MA DG Interconnection Tariff Change Request Form (2012)

Requester Name: Fran Cummings	Company Name: SEIA	Phone # : 978-985-1557
Date of Request: 8/22/12	Section of Tariff to be effected:	E-mail Address: fcummings@peregrinegroup.com
Requested Priority (emergency/high/low/editorial):	Requested Implementation Date:	Status:

Figure 1 – Schematic of Massachusetts DG Interconnection Process

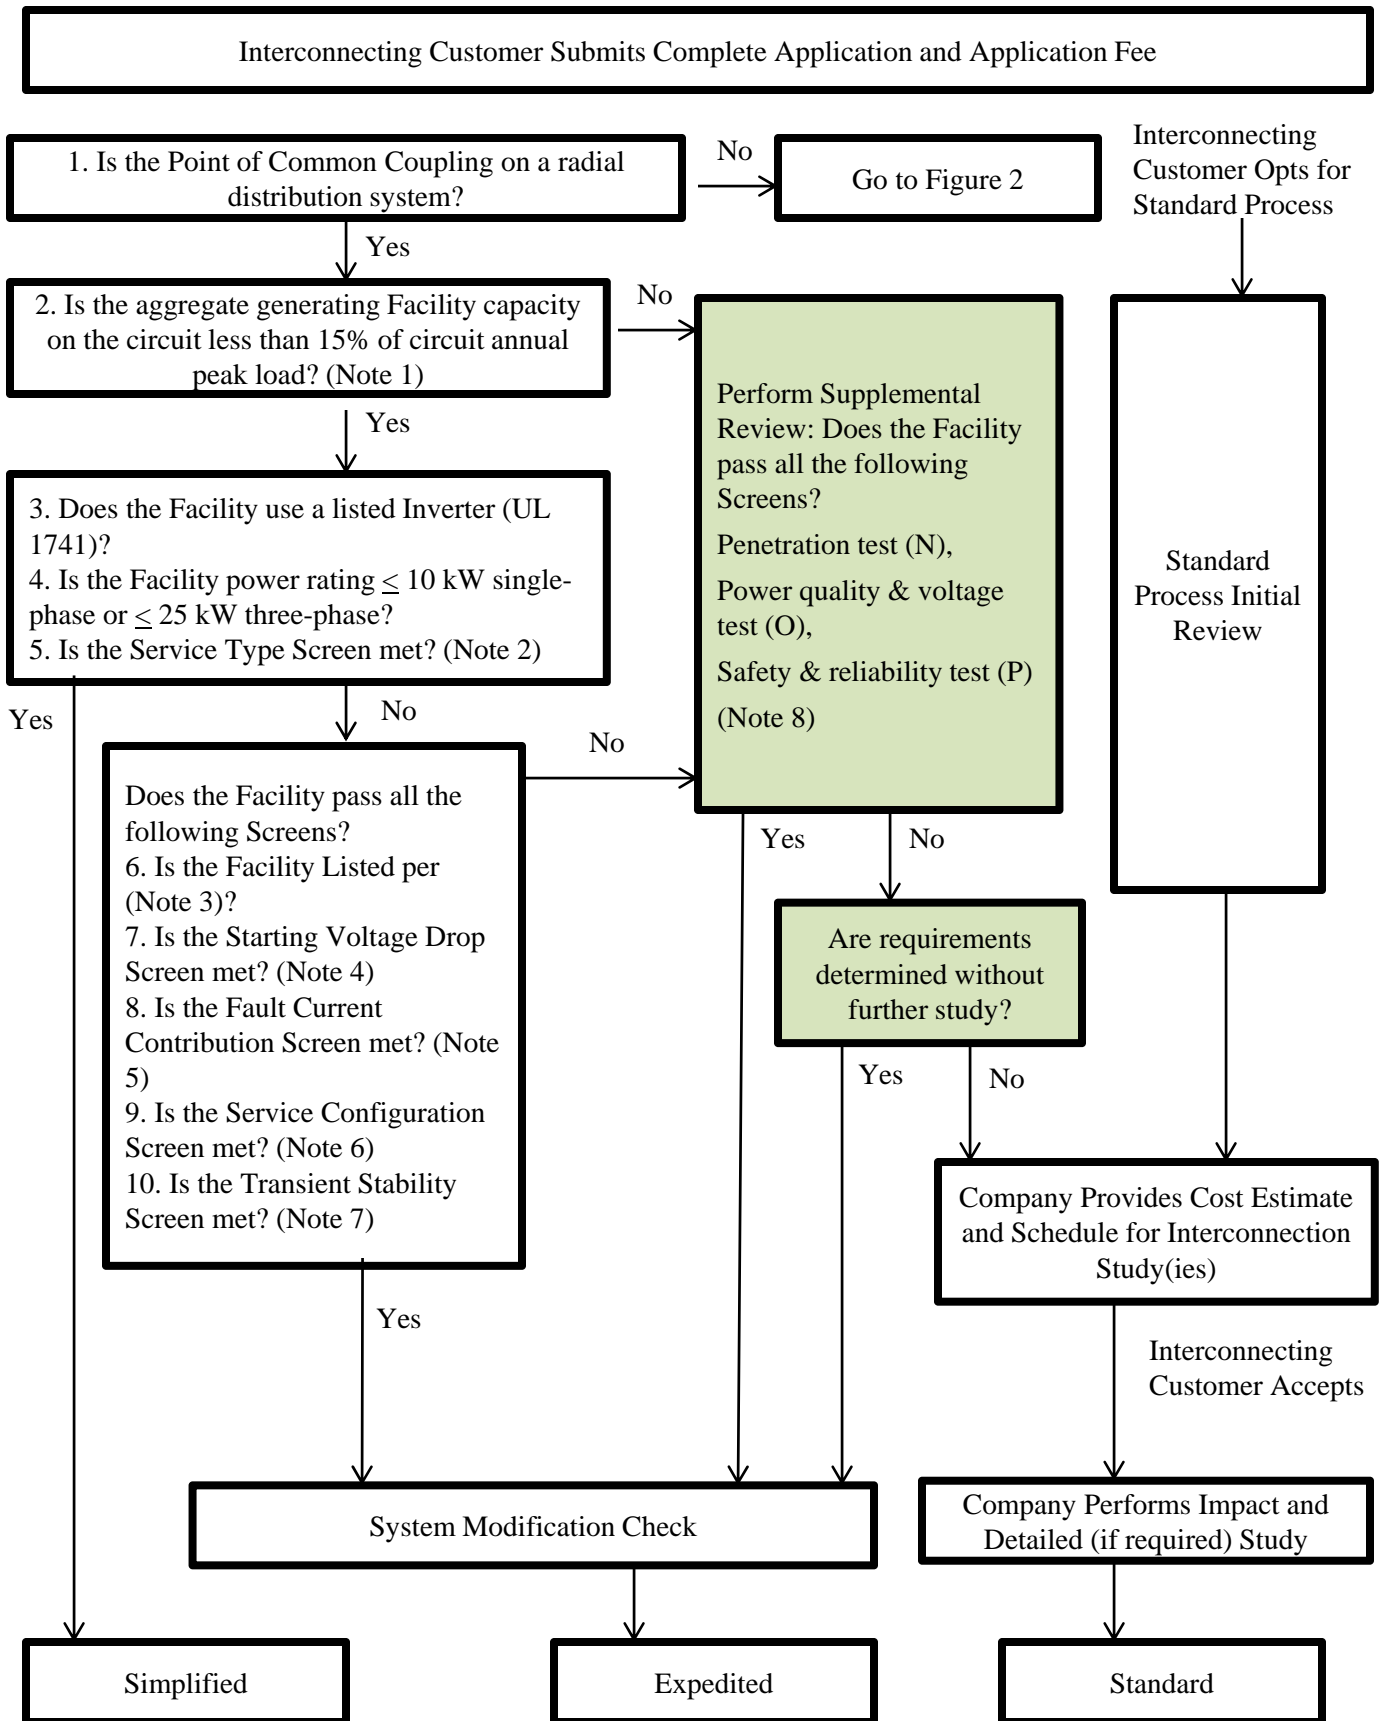
2.) As specified in attached version of Figure 1:

- Insert 3 screens in box “Perform Supplemental Review”, and

- Add new arrow specifying that if all 3 screens are passed, the Facility moved to the System Modification Check.
